Quality Bulletin

Service Action SP1087: PS3 RHS Outer Panel Model Year 2025 Polestar 3

SP1087

QB Instruction VCC-537329-1

Right-hand side

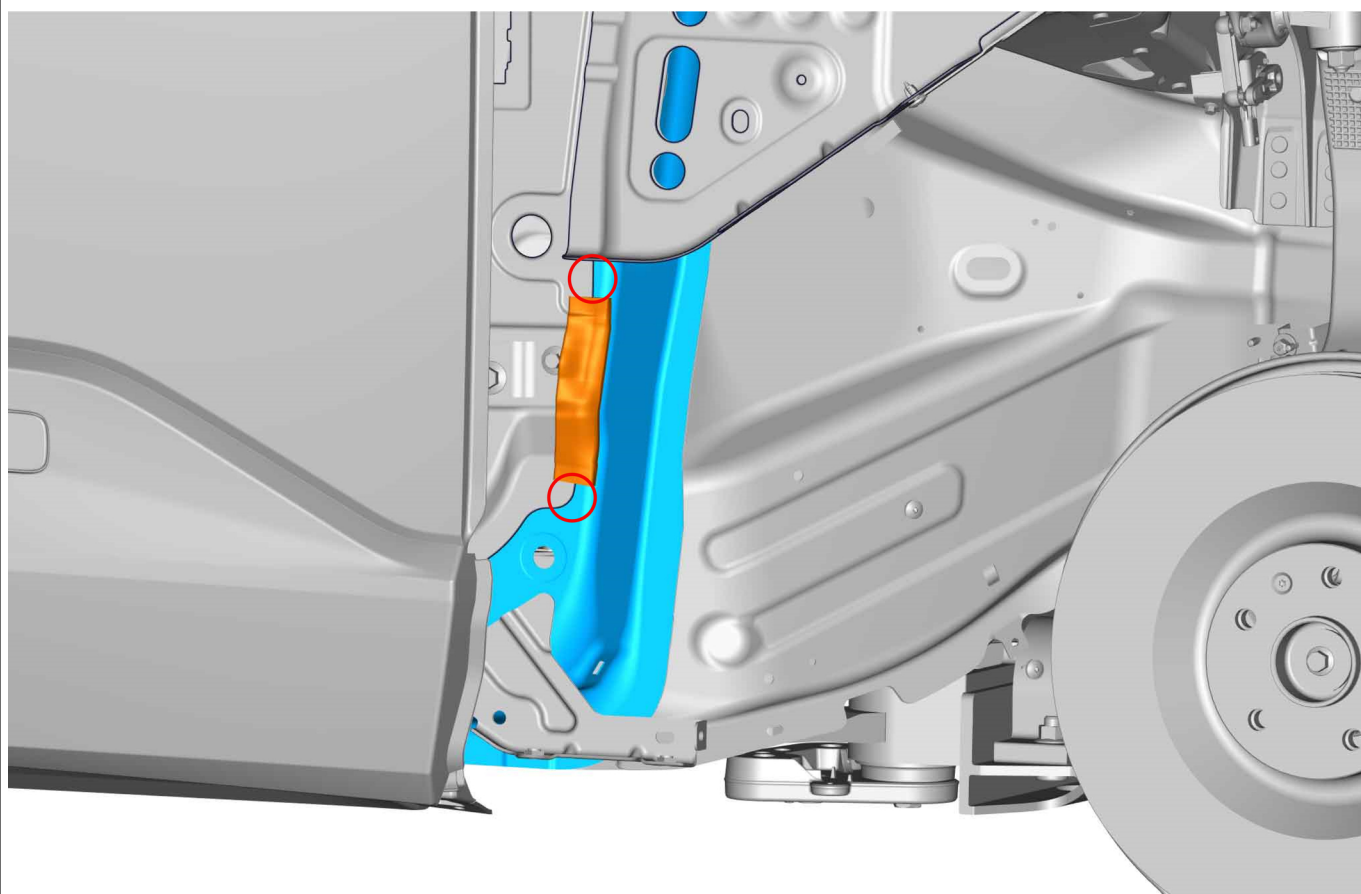
There is risk of water intrusion into the cavity between the A pillar and the body side outer panel, located behind the right-hand side lower door hinge. This is because of the sealant not being correctly applied to effectively prevent water ingress.

Remove front wheel arch liner , refer to:
Removal, replacement and installation
8 - Body and interior
86 - Bumpers and mudflaps
863 - protective shields and flaps

Note! Orientation view

Note! Make sure that the component is clean and free of foreign material.

Use: Isopropanol ,
